Agenda Item:	14.1
Source:	Alcatel
Title:	Proposal to remove the silence detection procedure in the user plane DCH FP (TS 25.427)
Document for:	Decision

3 Change proposal to TS 25.427

Figure 1. DCH Synchronisation procedure.

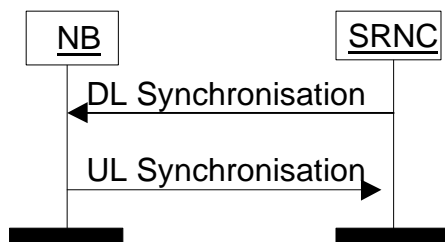
In synchronisation procedure the SRNC sends a DL SYNCHRONISATION control frame towards Node B. This message indicates the target CFN.

Upon reception of the DL SYNCHRONISATION control frame, Node B shall immediately respond with UL SYNCHRONISATION control frame indicating the ToA for the DL synchronisation frame and the CFN indicated in the received DL SYNCHRONISATION message.

The SRNC may send DL synchronisation control frames to the Node B, in order to maintain the synchronisation. On reception of the DL synchronisation control frame, the Node B shall reply with a UL synchronisation frame, as described in the synchronisation procedure below.
